ADDENDUM NO.: TWO

DATE OF ADDENDUM: January 24, 2013

**Renovations & Additions to Jenkins-Waggoner Laboratory
CAES, 123 Huntington St, New Haven CT 06511
BI – P – 86**

2 LOBBY INTERIOR ELEVATION

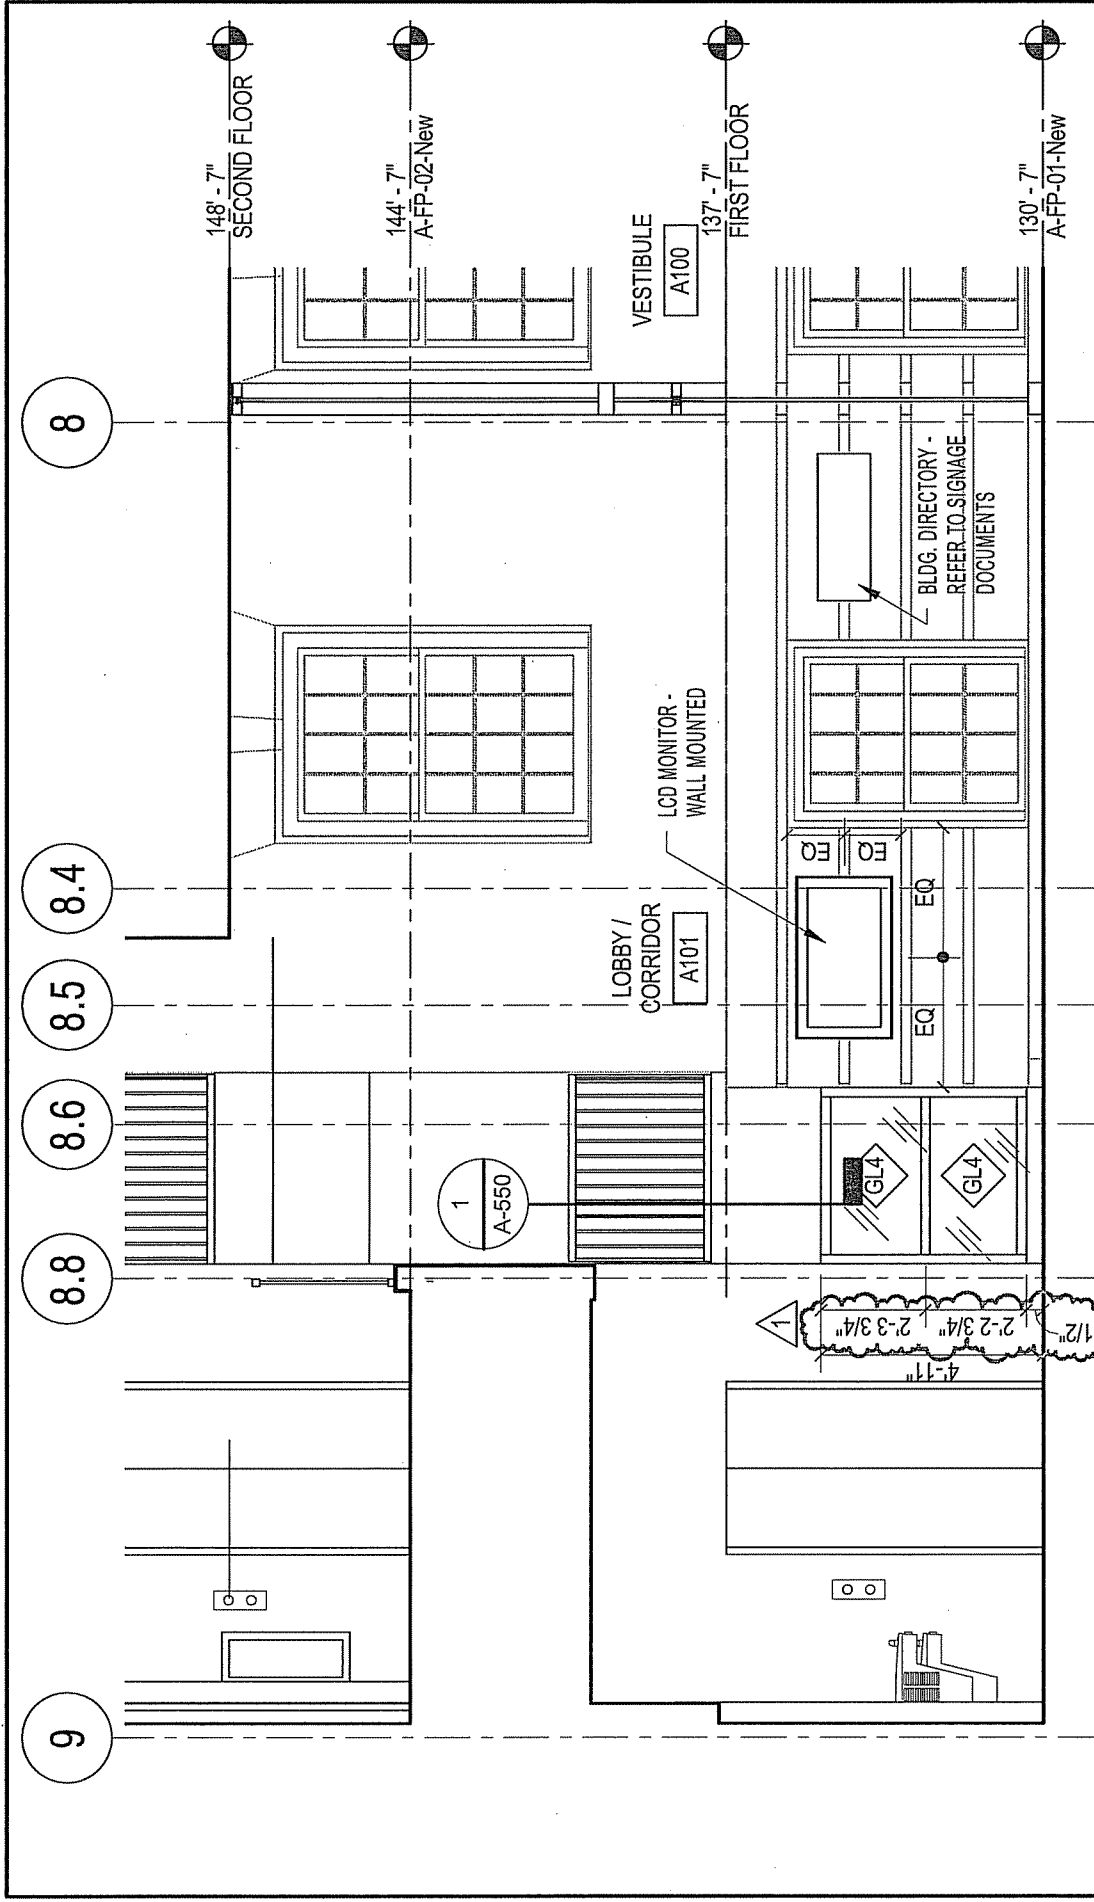
Drawing A-412. Dimensions clarified at interior borrowed lite. Refer to attached sketch ASK-A412c.

BASE DETAIL AT SOUTH CURTAIN WALL

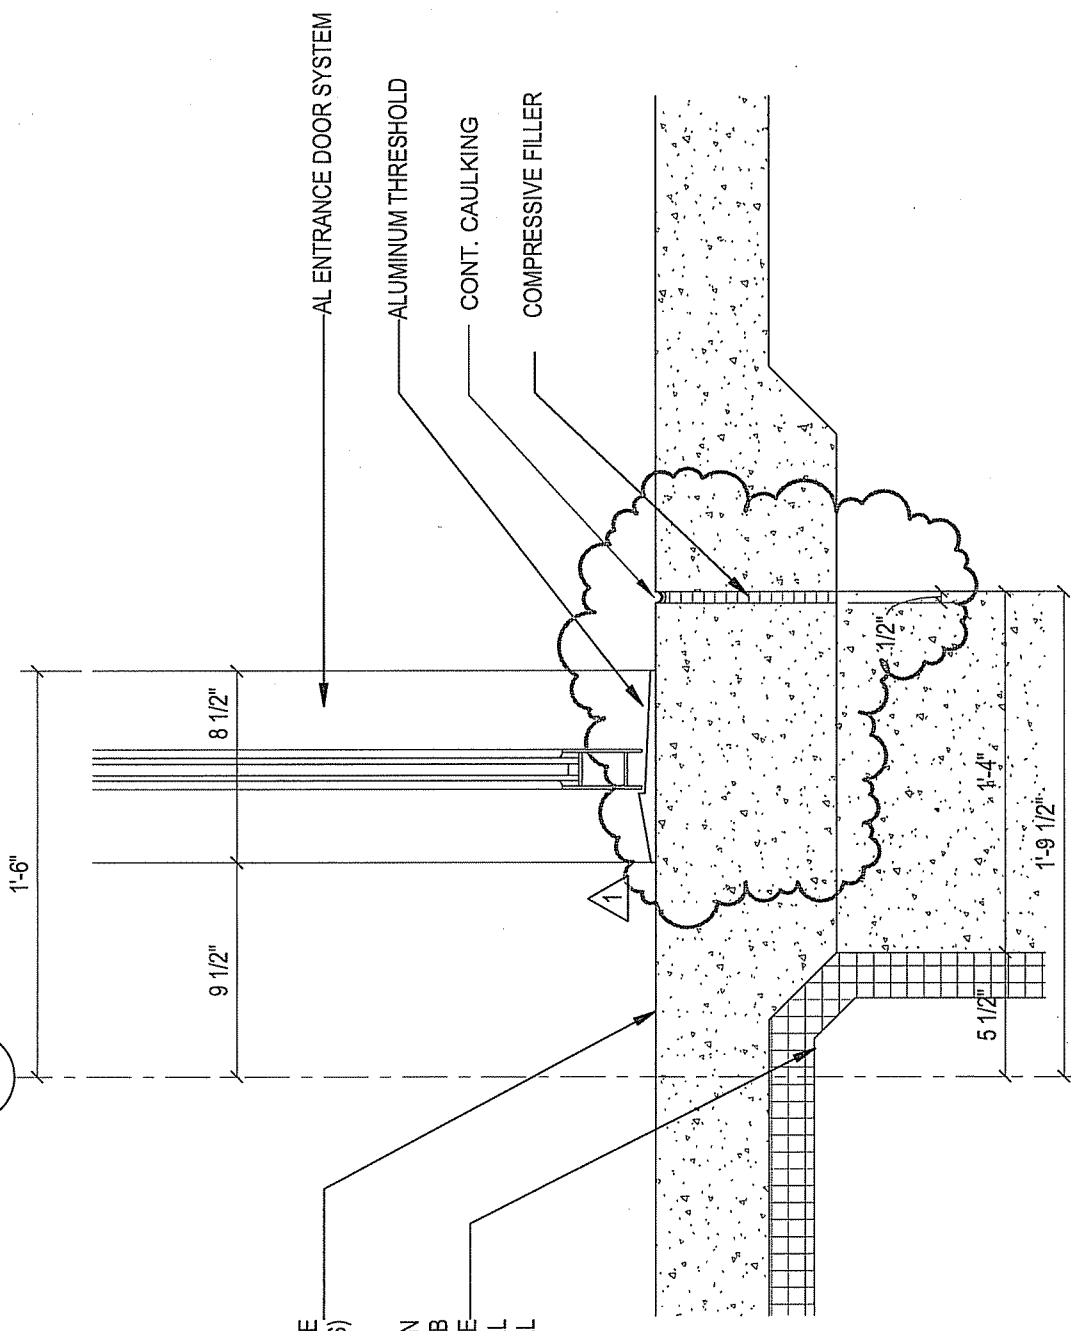
Drawing A-512. Coordinate edge of slab with structural design. Refer to attached sketch ASK-A512.

1 ENLARGED LAB ENTRY PLAN 004

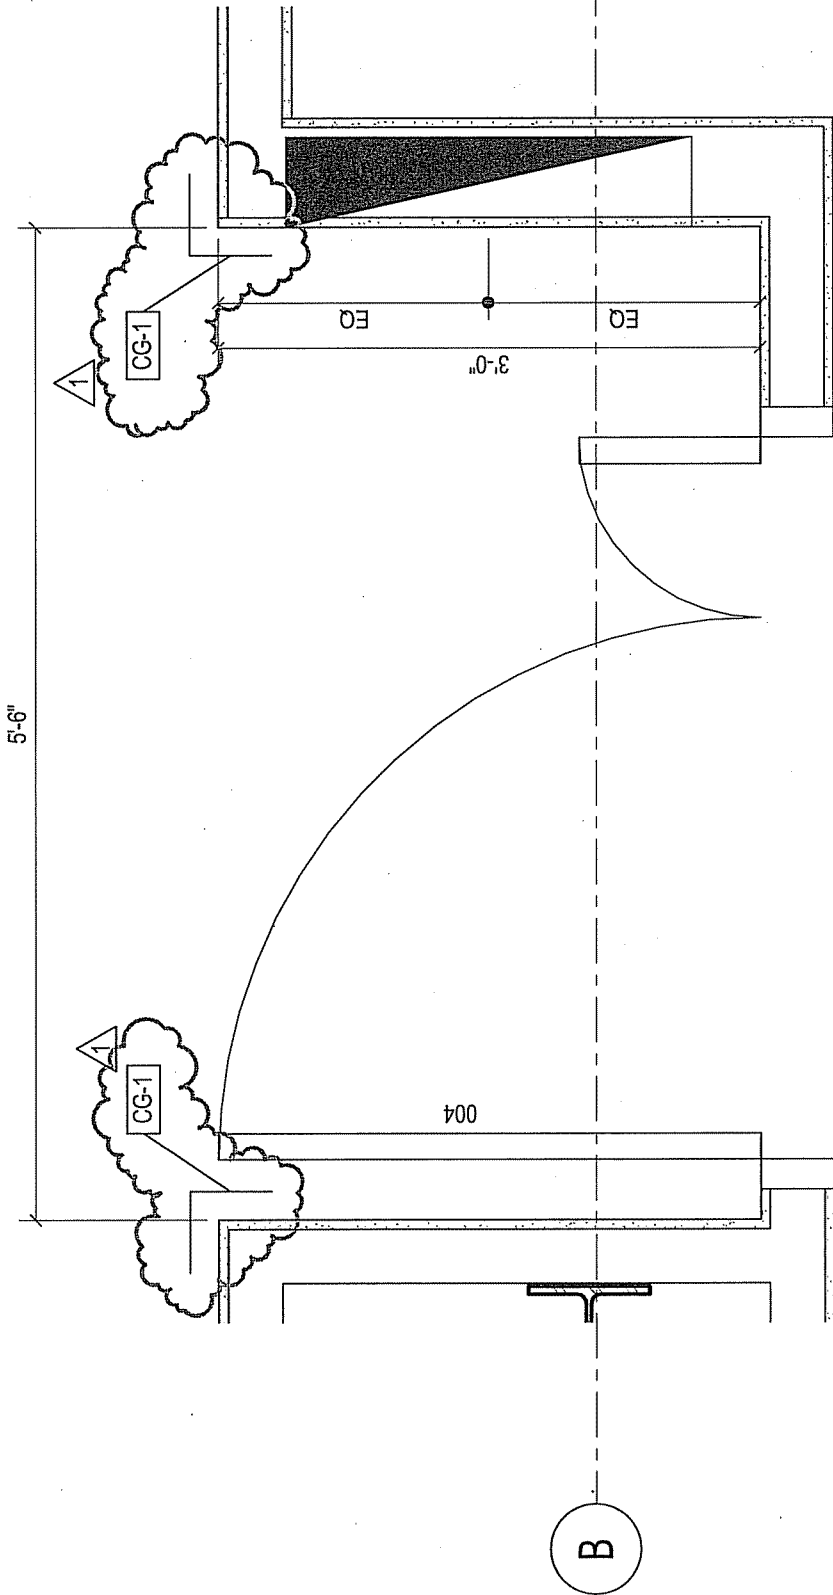
Drawing A-543. Corner Guards locations have been noted.. Refer to attached sketch ASK-A543a, ASK-A543b, ASK-A543c, ASK-A543d, ASK-A543e, ASK-A543f, ASK-A543g, ASK-A543f, ASK-A543g, ASK-A543h and ASK-A543i.

1 ENLARGED LAB ENTRY 112

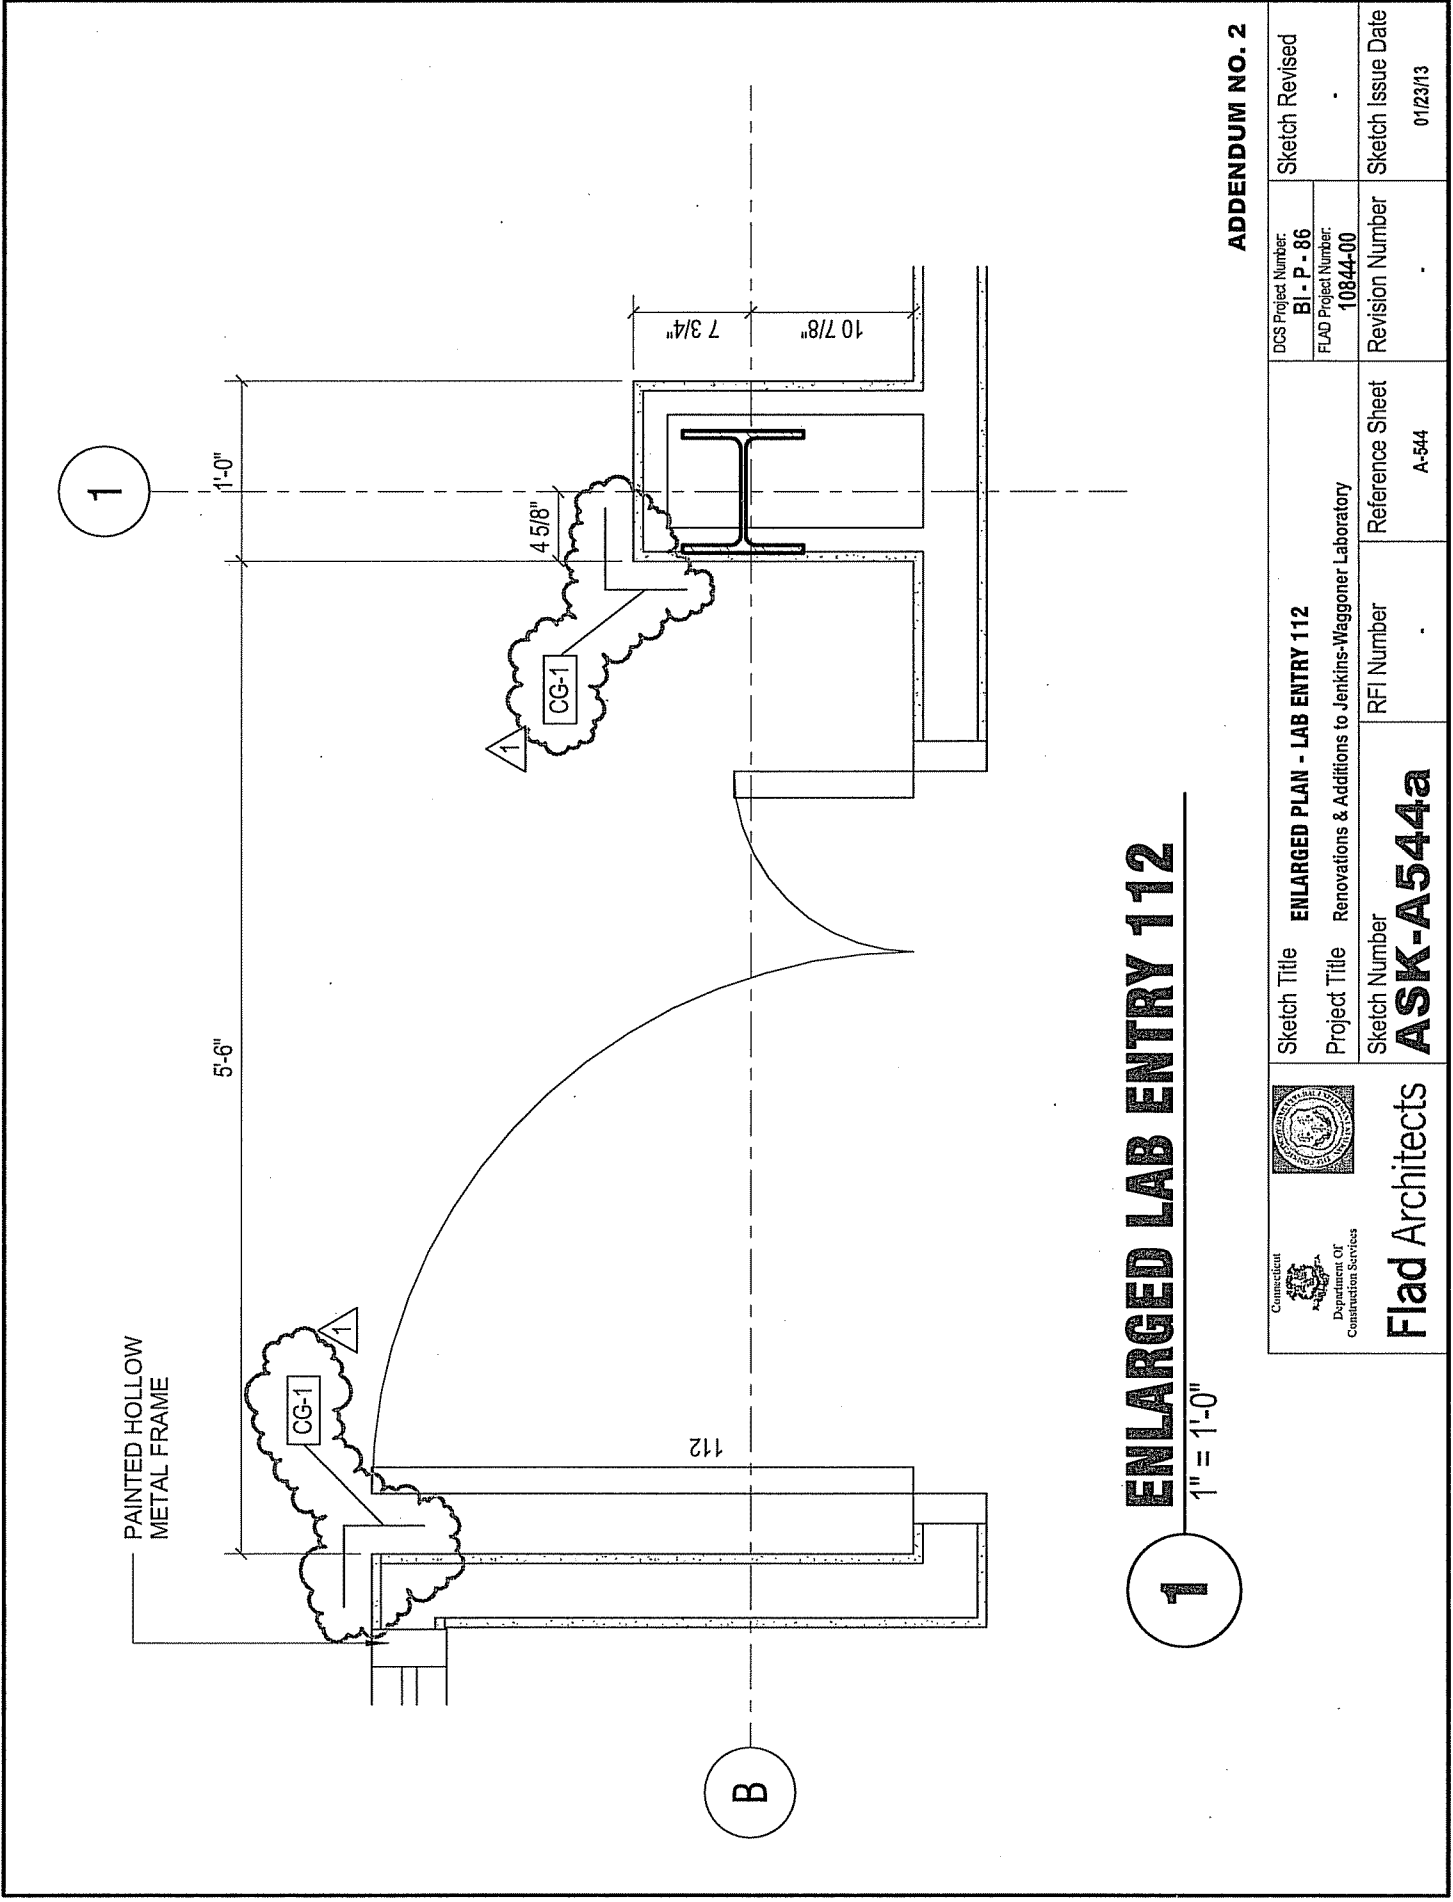
Drawing A-544. Corner Guards locations have been noted. Refer to attached sketch ASK-A544a, ASK-A544b, ASK-A544c, ASK-A544d, ASK-A544e, ASK-A544f and ASK-A544g.
